GEOCRES No. 31F-111

W.P. No. 81-83-01

From: Ted Phillips
To: MTOHO3.TES.Dundas
Date: 1/10/96 5:37pm
Subject: Culvert Recommendations - Highway 41

Re : Culvert Review
Township of Denbigh
W.P.81-83-01, Site N/A
Hwy. 41, District 10, Bancroft

Photo (3) View through 1.2m CSP
Sta. 17+238 - TWP Of Denbigh

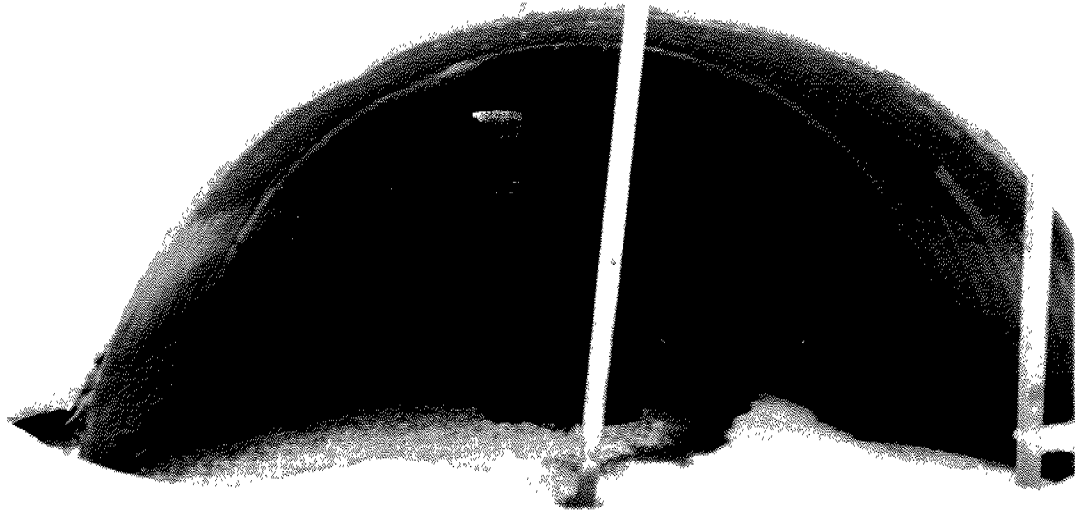
The existing 1.22 metre CSP has buckled slightly at the approximate location of the existing slope failure area. Also the culvert has apparently been broken based on District Maintenance information which indicates there has been some filtration of material into the culvert at the approximate buckled area site which required flushing out.

There is also some corrosion of the bottom half of the CSP (Photo 3). Although it does not appear to have affected the culvert performance or structural integrity, the MTO Eastern Region Structural Section should review the condition during 1991.

1. The MTO Eastern Region Structural Section should review the existing 1.22 metre CSP to ascertain structural integrity.
2. If the culvert is structurally sound and does not require immediate replacement, then a short section of pipe placed inside the existing culvert from the inlet (west) to beyond the buckled area could be considered as a short term solution until the culvert must be replaced for structural reasons.
3. If the culvert requires replacement then a foundation type investigation should be carried out to ascertain the extent of the shear failure problems and the overall remedial treatments required. Failure to address the stability/fill movement problems during the culvert replacement will almost certainly result in similar type of culvert problems in the future.
